# INITIAL FIRE SAFETY INSPECTION REPORT

**Chaity Composite Ltd.- Annex building**

**RSC ID: 24170**

**Date: 15-Mar-2021**

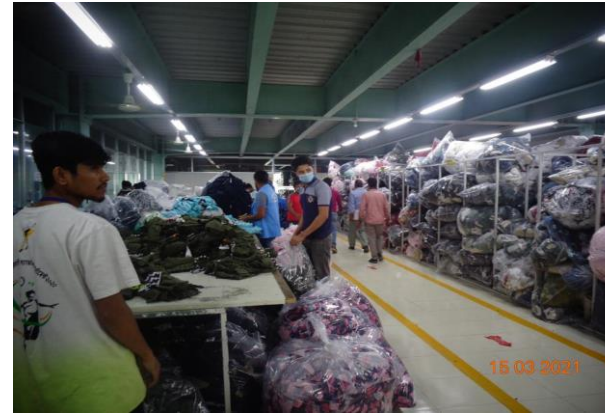
F-2	Fire Rated Construction	Elevator shafts are directly open into the inside of stair-1(Garments building) & Stair-1(share Store building)	For new construction, elevators shall not open into an exit enclosure as per ACCORD Standard-6.14.3. So, separate the stair enclosure from elevator shaft .	Within 3 months
-----	-------------------------	---	---	-----------------

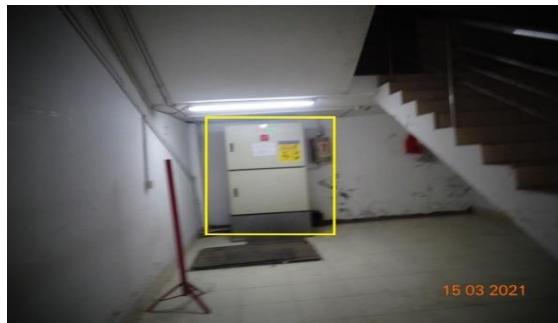
F-15	Means of Egress	The common path of egress travel was founded more than 23m located at first floor of Annex building.	Reconfigure the egress arrangement to reduce the maximum common path of travel to not more than 23m or 30m when complete sprinkler protection is provided	Within 3 months
<div style="display: flex; justify-content: space-around;">   </div>				
F-16	Means of Egress	A single means of exit has been provided at 6th floor .	Provide additional required remotely located exit stair from 6th Floor.	Within 3 months
